# Flowchart of alternative method validation/revalidation

MLIT is planning to present this proposal for whole alternative methods (including wind tunnel not fulfilling criteria) at WLTP-IWG, since CFD sub-wg covers discussion about CFD, not other alternative methods.

MLIT requests the further discussion on the following area when JPN introduces CFD method into JPN legislation in the future. (It is okay to introduce to EU legislation (=Lv.1a of UNR-WLTP) and GTR15 amendment 6.)

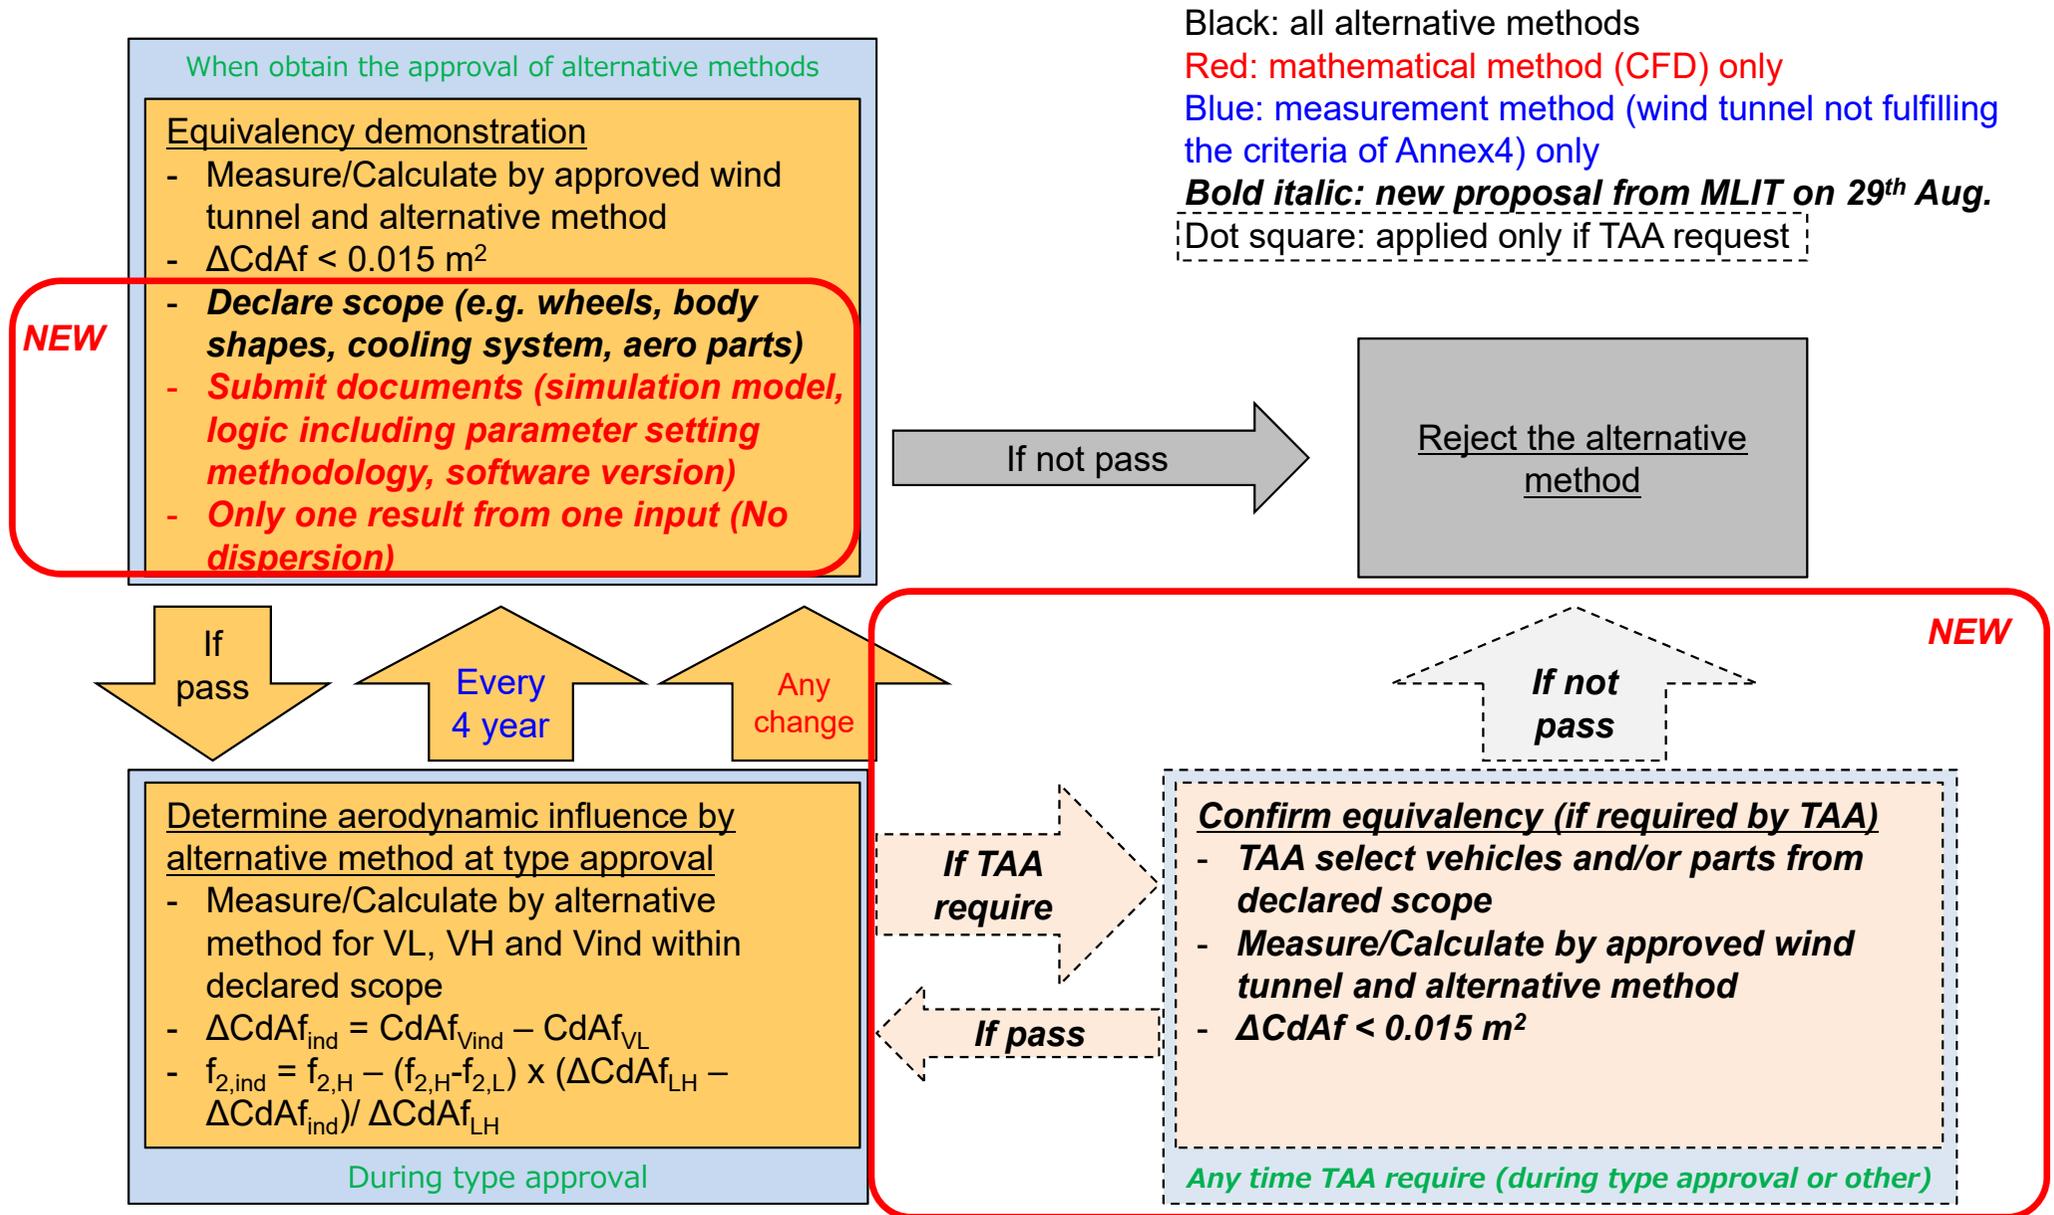
Necessary to determine the declared scope of "determine aerodynamic influence by alternative method" and to limit the scope of "Confirm equivalency" within availability of equivalency

Necessary in order to make it clear if the manufacturer change some part of the alternative method

There should not be ambiguity in the type approval procedure.

Necessary because there should be procedure that deter misuse of alternative method.

This concept is comply with the general requirement about road load (Annex4 3.).
